DRAINAGE CERTIFICATION
I, BRIAN H. WARREN, NMPE 20011, OF THE FIRM BOHANNAN HUSTON INC., HEREBY CERTIFY THAT THIS PROJECT HAS BEEN GRADED AND WILL DRAIN IN SUBSTANTIAL COMPLIANCE WITH AND IN ACCORDANCE WITH THE DESIGN INTENT OF THE APPROVED PLAN DATED 08/19/2012. THE RECORD INFORMATION EDITED ONTO THE ORIGINAL DESIGN DOCUMENT HAS BEEN OBTAINED BY BRIAN MARTINEZ, NMPS 18374, OF THE FIRM CARTESIAN SURVEYS INC. I FURTHER CERTIFY THAT I HAVE PERSONALLY VISITED THE PROJECT SITE ON 01/30/2013 AND HAVE DETERMINED BY VISUAL INSPECTION THAT THE SURVEY DATA PROVIDED IS REPRESENTATIVE OF ACTUAL SITE CONDITIONS AND IS TRUE AND CORRECT TO THE BEST OF MY KNOWLEDGE AND BELIEF. THIS CERTIFICATION IS SUBMITTED IN SUPPORT OF A REQUEST FOR PERMANENT CERTIFICATE OF OCCUPANCY.

PROJECT: MOUNTAIN AMERICA CREDIT UNION
ALBUQUERQUE BRANCH
PASEO DEL NORTE & VENTURA ST. - PARCEL B
ALBUQUERQUE, NM 87109

SHEET TITLE: GRADING PLAN
SHEET NUMBER: C-201
SCALE: 1" = 20'

SHEET TITLE: **GRADING PLAN**
SHEET NUMBER: **C-201**

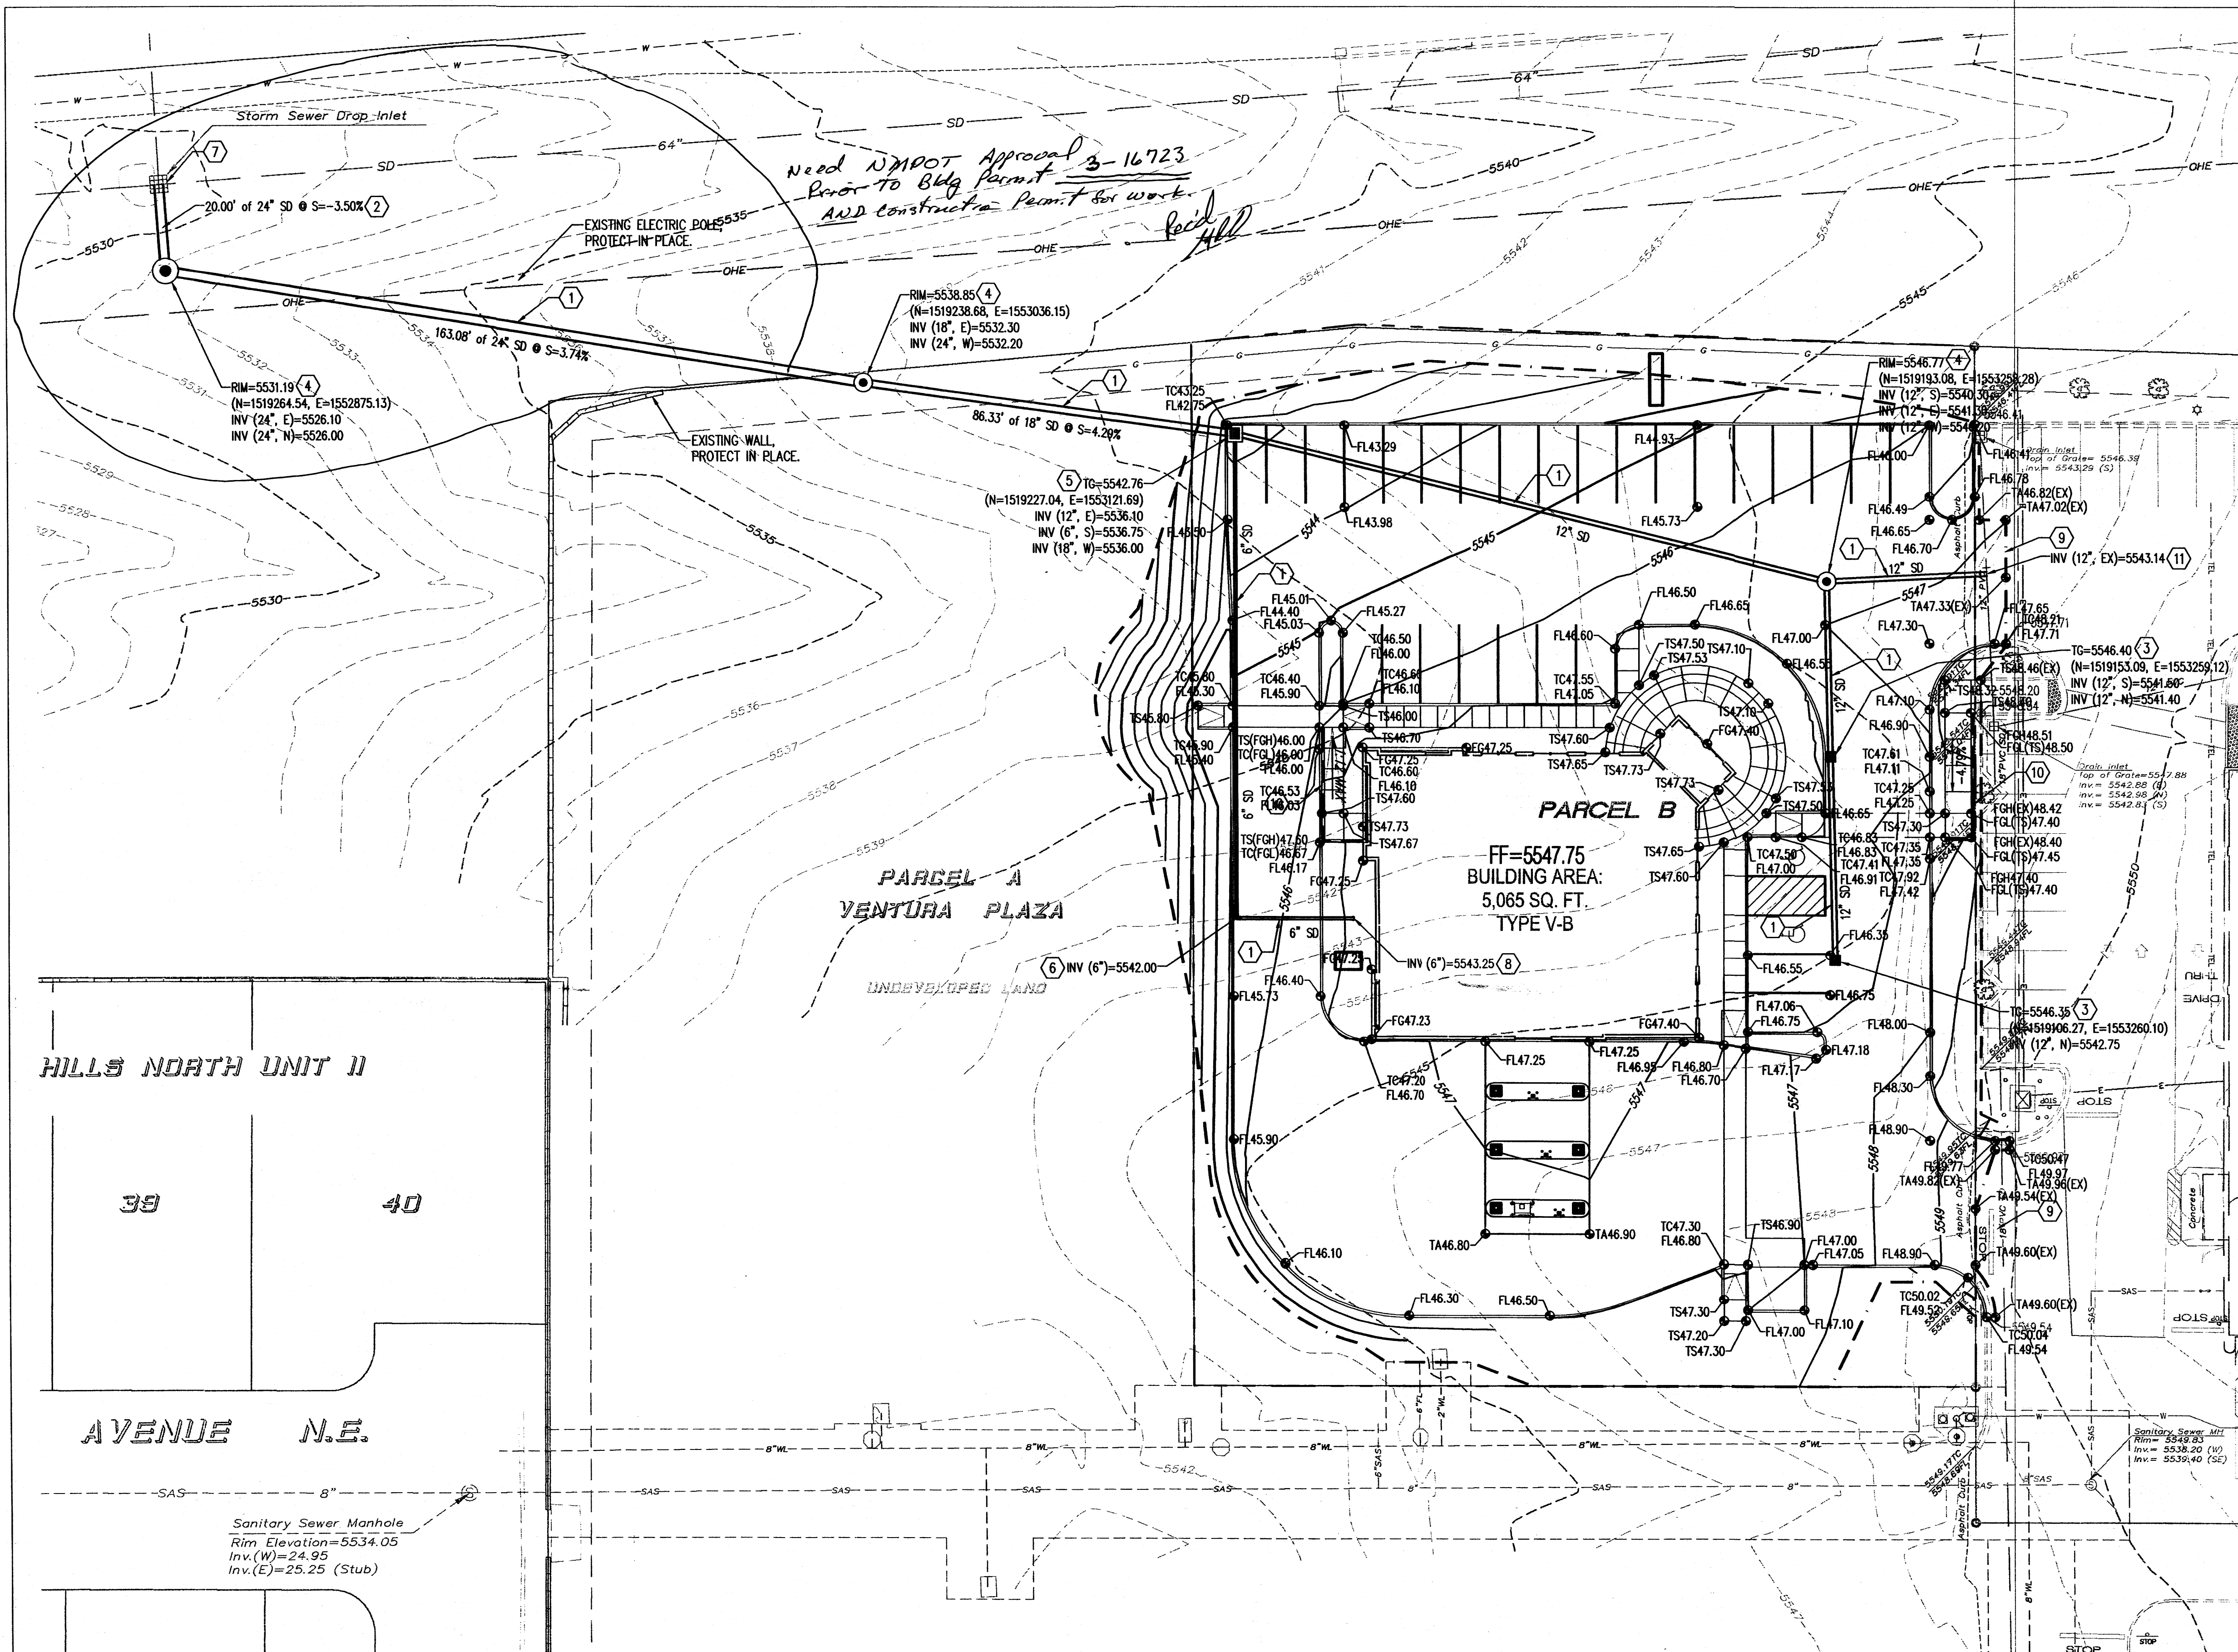
At Inlet per OMP.

Grandy map on text. Provide Loc. MAP on CERT.
